City of Franklin

Meeting Agenda

Tuesday, August 13, 2019

WOOD DUCK COURT PUD SUBDIVISION
 RESOLUTION 2019-56
 ORDINANCE 2019-20
 FRANKLIN MUNICIPAL PLANNING COMMISSION
 06/27/2019

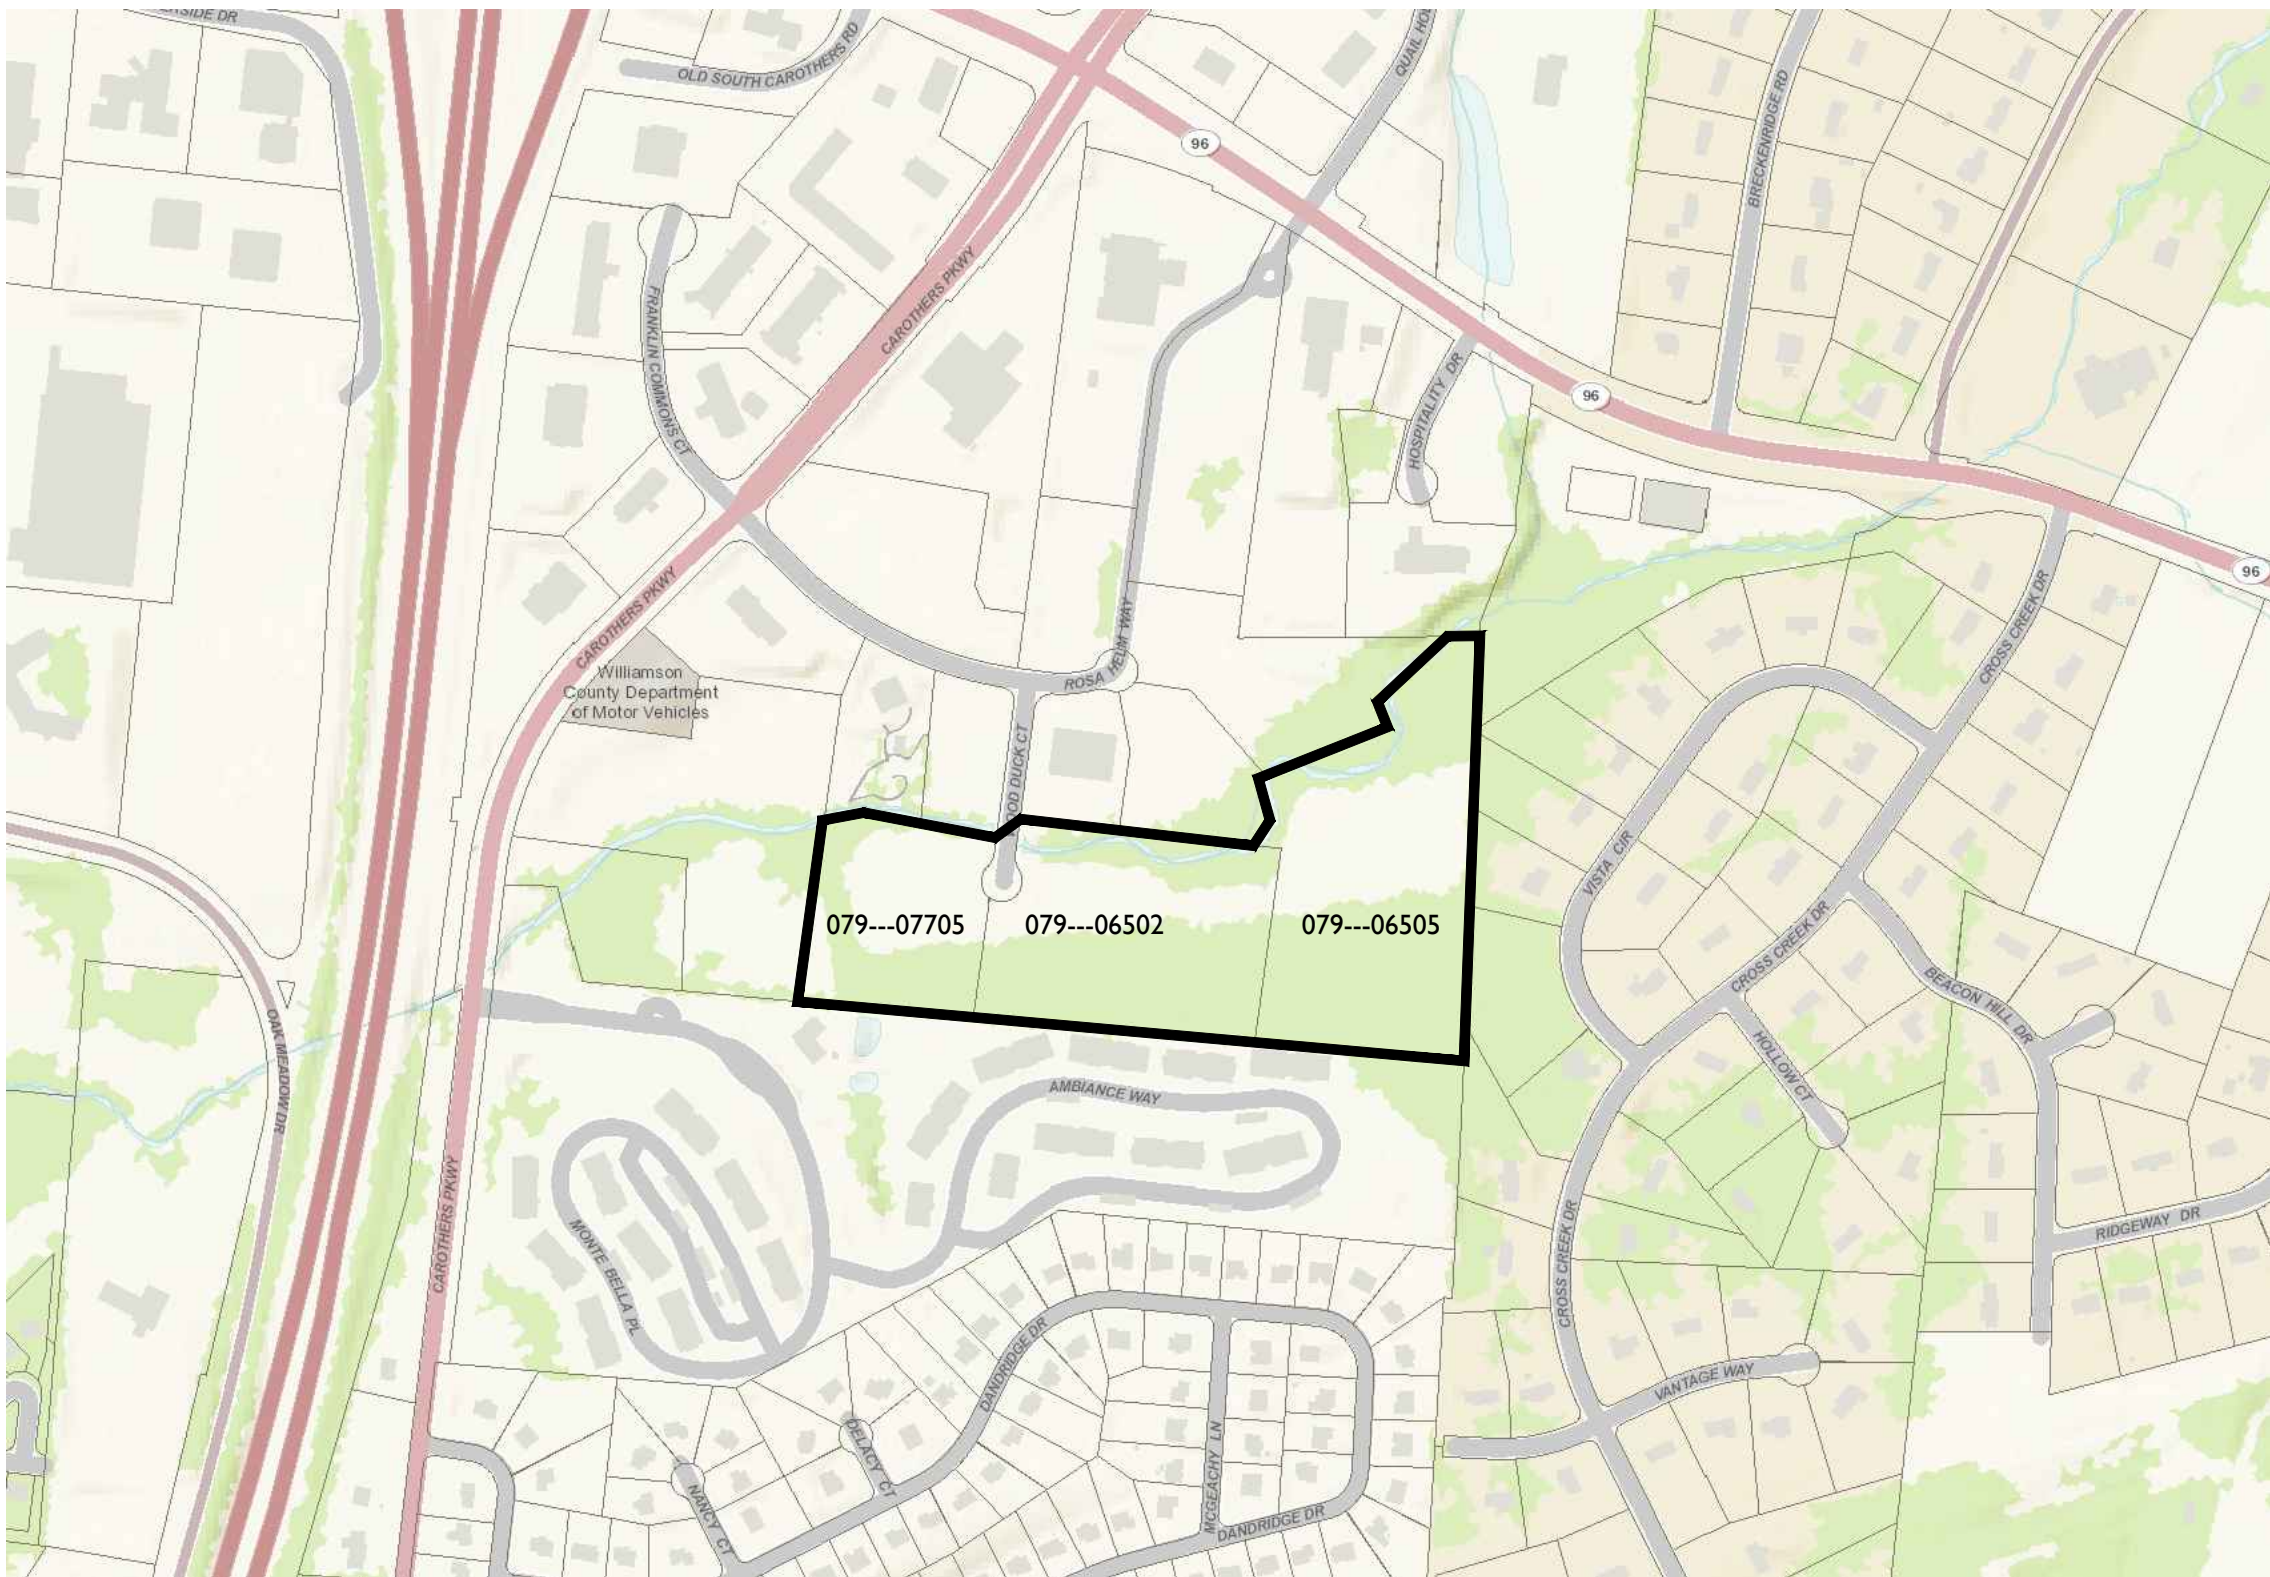
9. Cover Sheet Note

Applicant to place the following note on the Development Plan Cover Sheet:

"Comprehensive review of roadway, stormwater, and utility elements by City of Franklin Staff will occur at the Site Plan stage. Project entitlements approved with this Development Plan do not constitute approval of the roadway, stormwater, and utility elements shown on the Development Plan. If, upon application of City of Franklin street, stormwater, and utility standards at the Site Plan stage, the applicant cannot achieve the maximum approved entitlements, the applicant shall be confined to the entitlements achievable from the application of said standards."

Note added.

Note has been provided on the cover sheet (thank you). Note shall remain open to serve as a Condition of Approval.

SHEET
C2.0

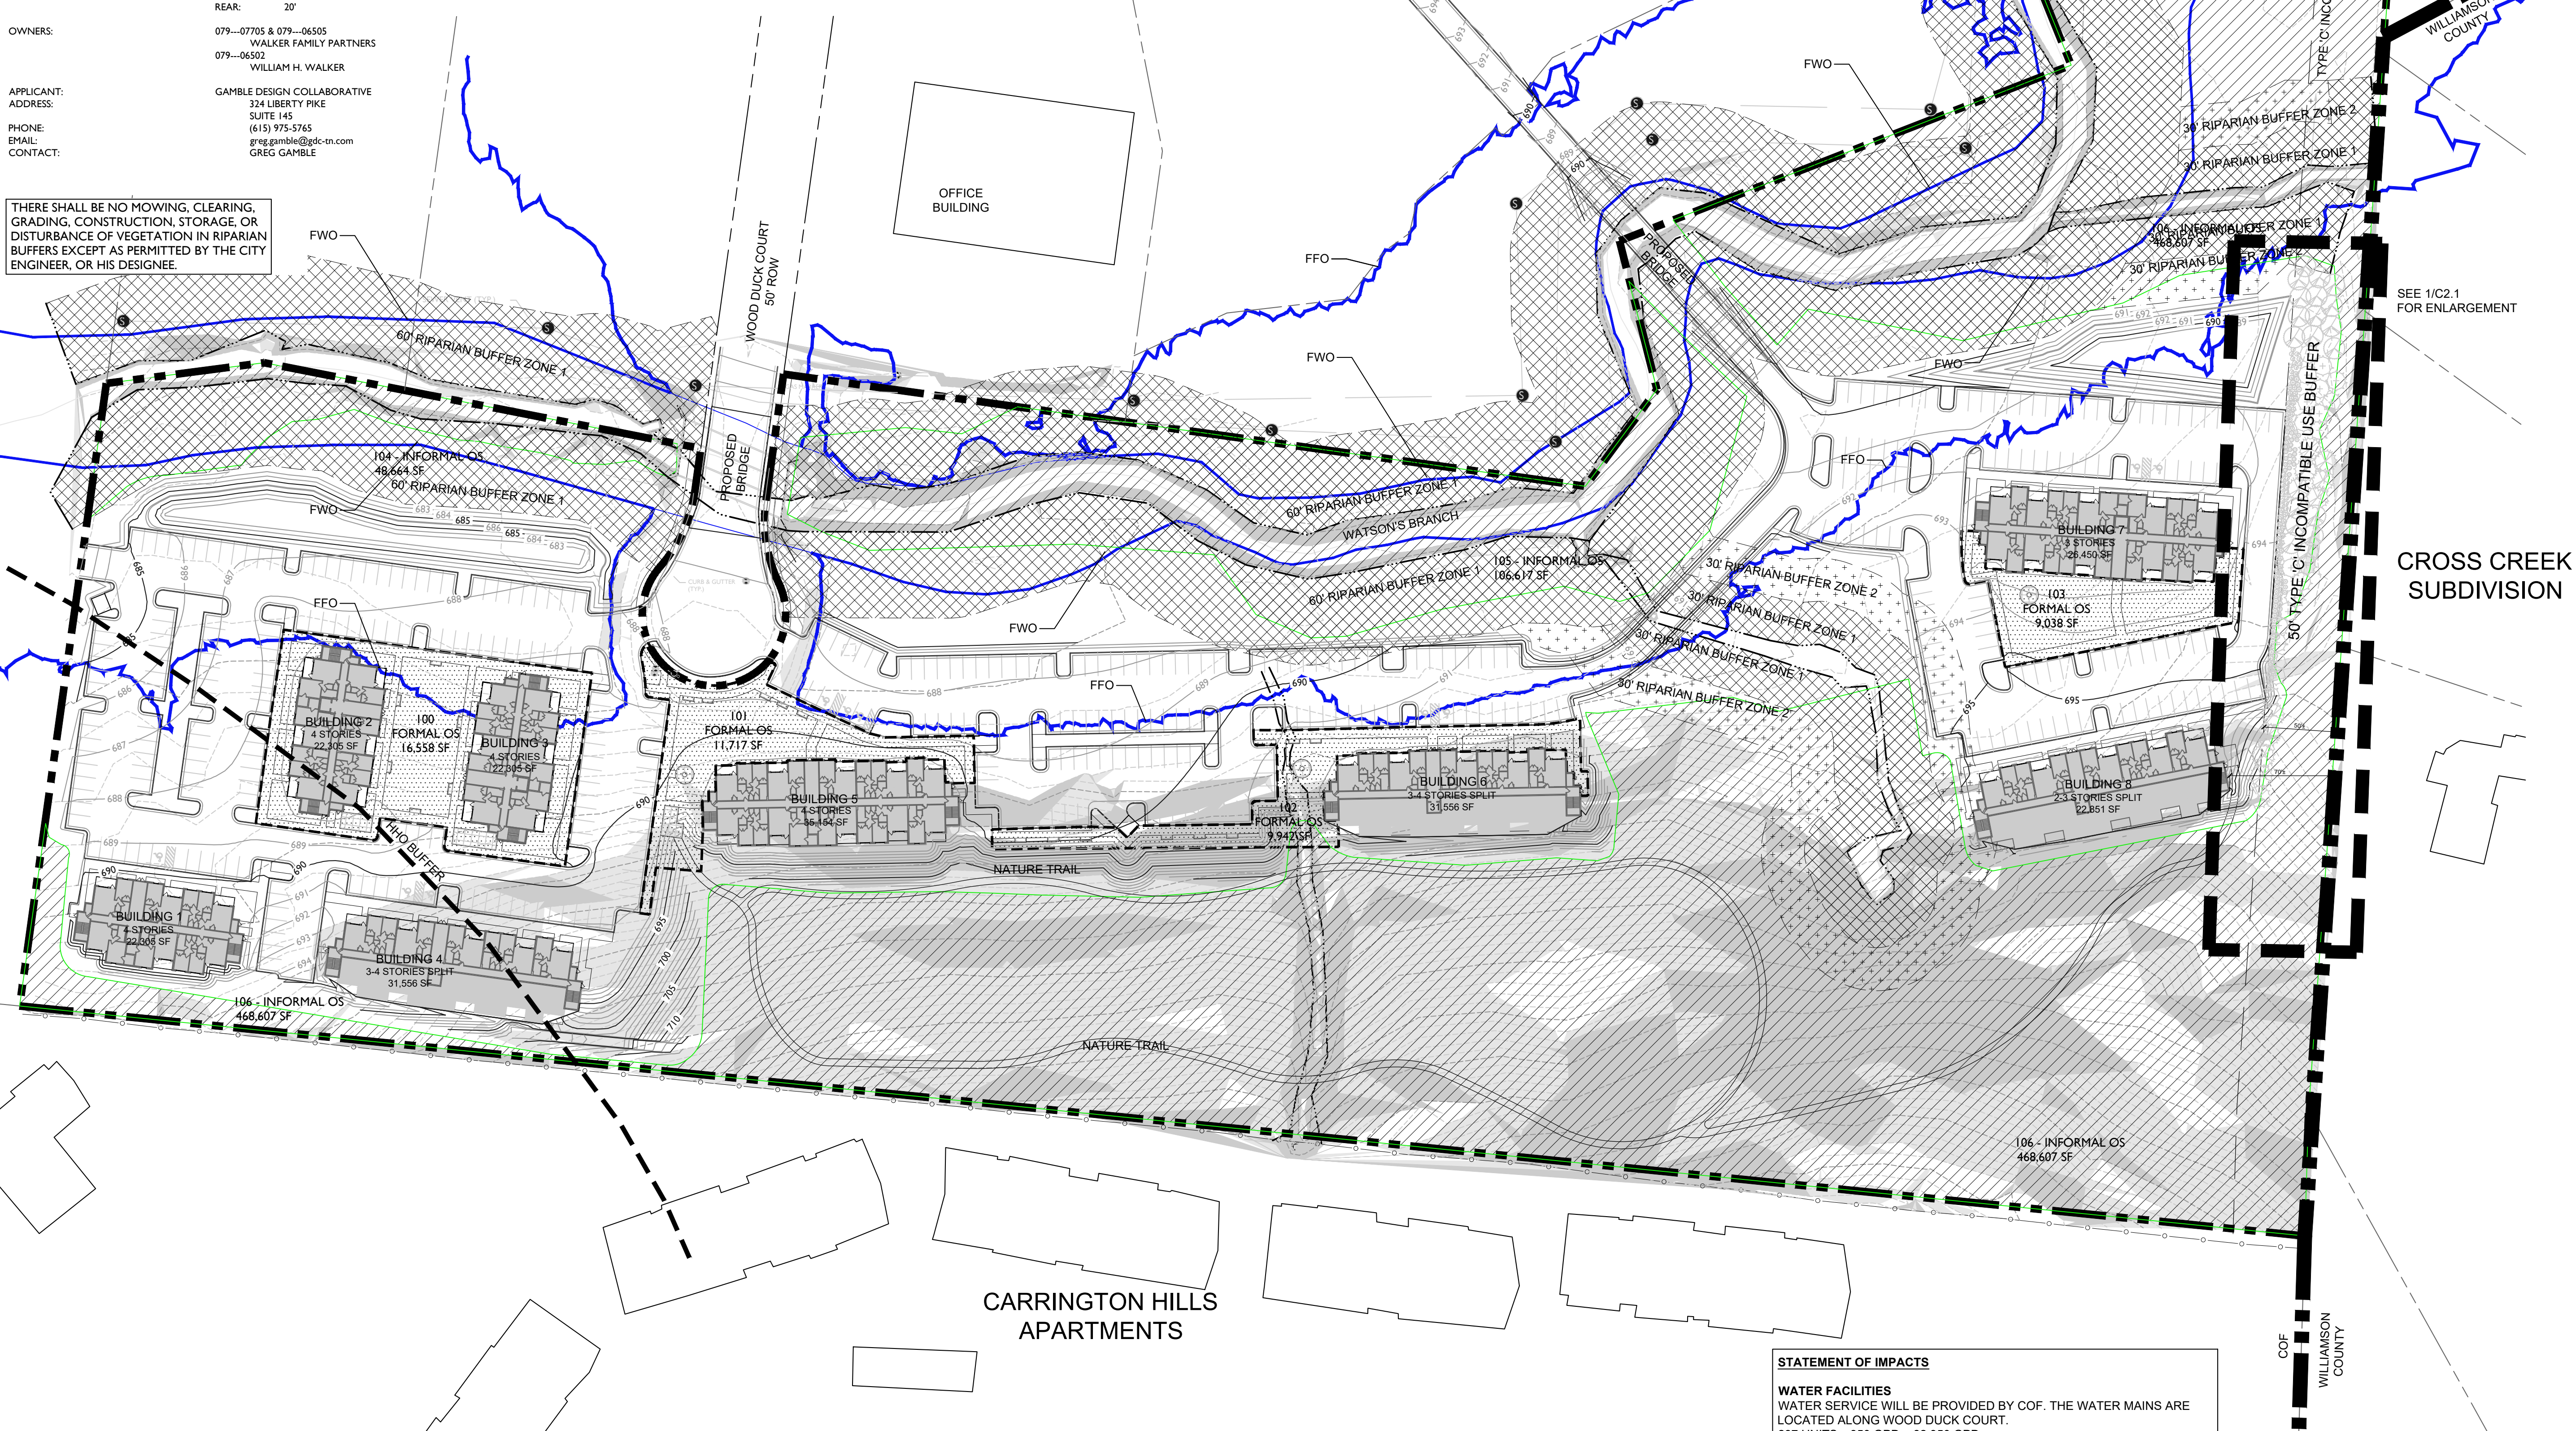
Identify the sidewalk between buildings 6 and 7 in more detail on sheet C2.0. It is hard to see on current plans.
[Edited By Amy Diaz-Barriga]

greggamble209@gmail.com Sidewalk has been added.

TYPICAL
ROADWAY CROSS SECTION
N.T.S.

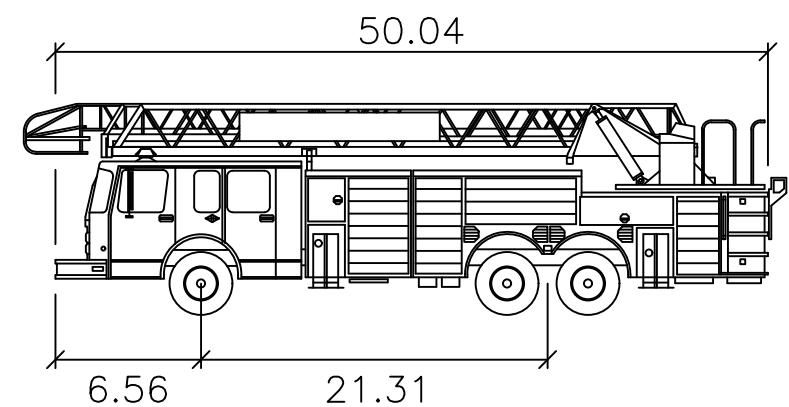
Add a roadway cross section for the access drive and new bridge. The access should be wide enough to allow for two-way traffic.

Applicant shall include a roadway typical cross-section detail for the access drive, indicating pavement width and how roadway drainage is accounted for. (Cross-slope of the drive, type of curb, if gutter or ditch sections are to be used.)

Applicant shall add a label specifying the cross-section is applicable only to the access drive. Applicant shall add note below cross-section: "Preliminary design only, curb and pavement details to be finalized at the site plan stage."

Access drive has been dimensioned on plans to show two-way traffic is allowable.

A typical roadway cross section has been added to sheet C4.0.
